PlanGrid Task Report - Mar 6, 2025

L05434_Westerville FSU (OH)

680 Polaris Parkway, Westerville, Ohio

Screenshot_20250306_101719_Symbio

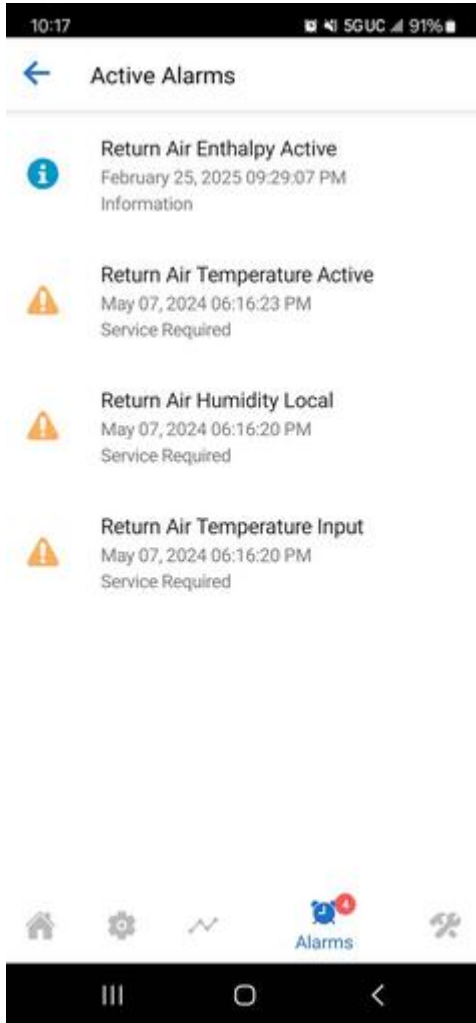
(Averaging) Sensors not communicating properly, check for correct terminations, correct dip switch / jumper settings, and shorts to ground on AC#3. Currently AC#3 is using return duct temperature sensor to control unit.

IMG_9541

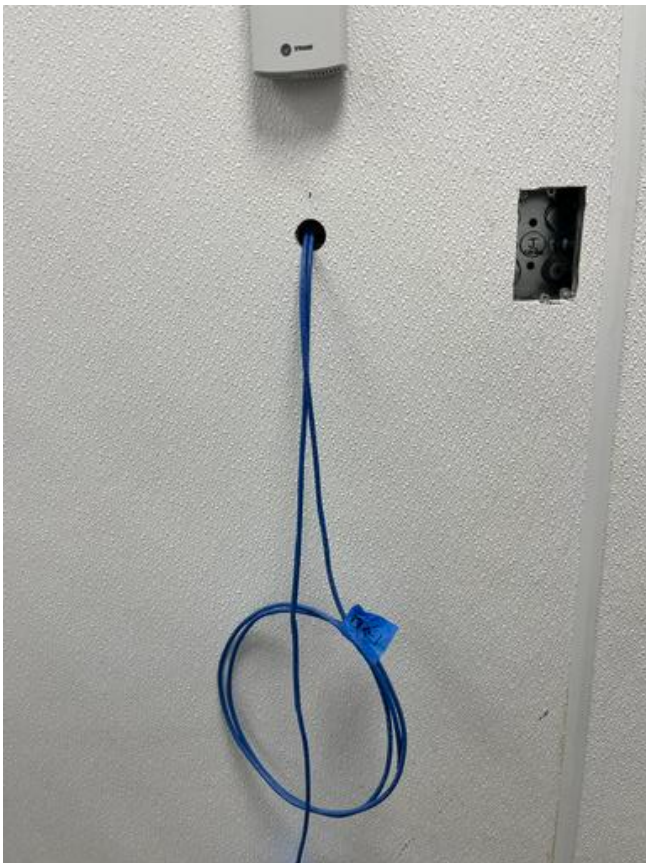
Thermostat sensor not installed outside office on AC#4.

IMG_9531

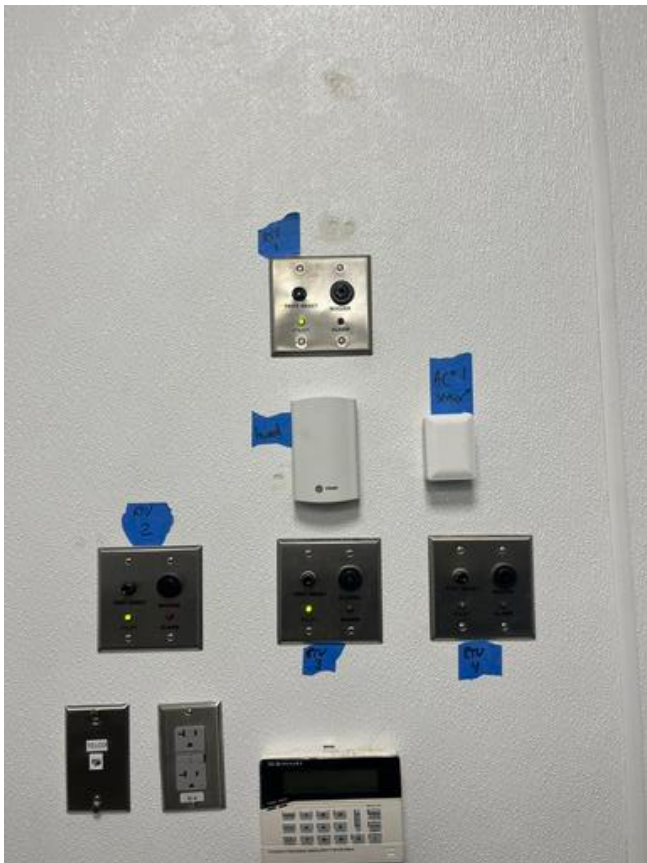
Label all sensors,
humidistats, thermostats,
and smoke annunciators.
